Re: Revised Heat Input Curves - FPC Hines Facility

This application is for the proposed revision of the heat input curves for Units 1A and 1B.

Request for Additional Information Regarding AC Permit Modification

FPC Hines Energy Power Block I, 1050234-002-AC

Heat Input Curve, Rev 01:

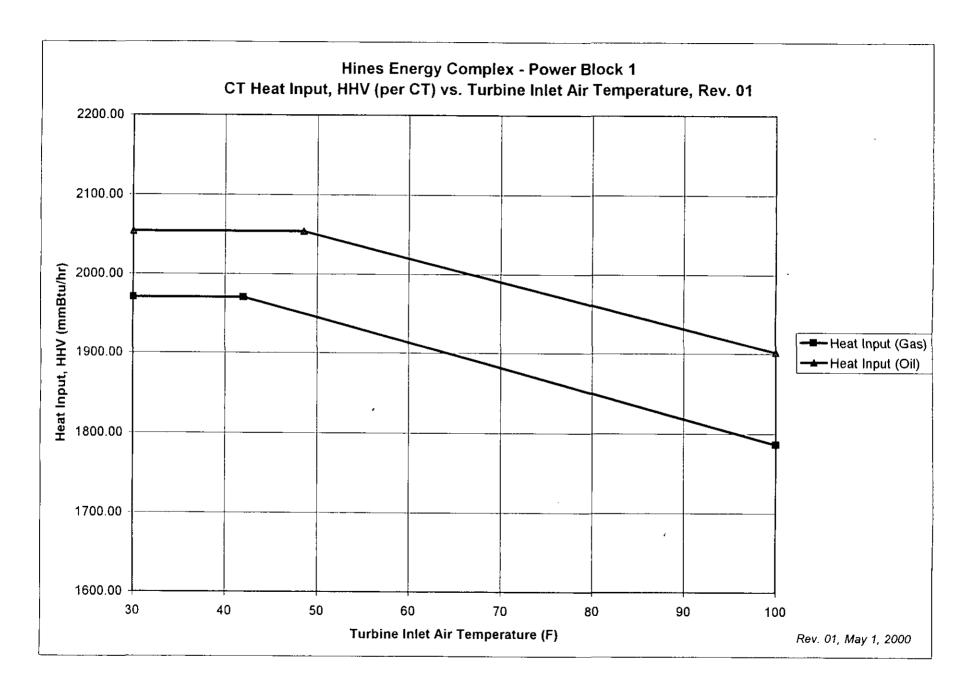
1. We understand that there is an approximate 1% increase at ISO conditions in the overall maximum heat input from the original permitted limit. At the upper end of the temperature range, the maximum heat input for both natural gas and oil firing, reflect an increase of 5% or more over the current permit's curve. Please provide actual test data for both oil-firing and natural gas-firing to support such a change at the high temperature ranges.

I have enclosed hardcopies of the proposed revised heat input curves and the supporting test data for Units 1A and 1B at Florida Power Corporation's (FPC) Hines Energy Complex. This information was previously sent to Mr. Russell Wider by email, and this submittal formalizes that transmission. FPC requests that DEP issue the construction permit amendment as soon as possible in order to enable FPC to utilize the available capacity at Hines.
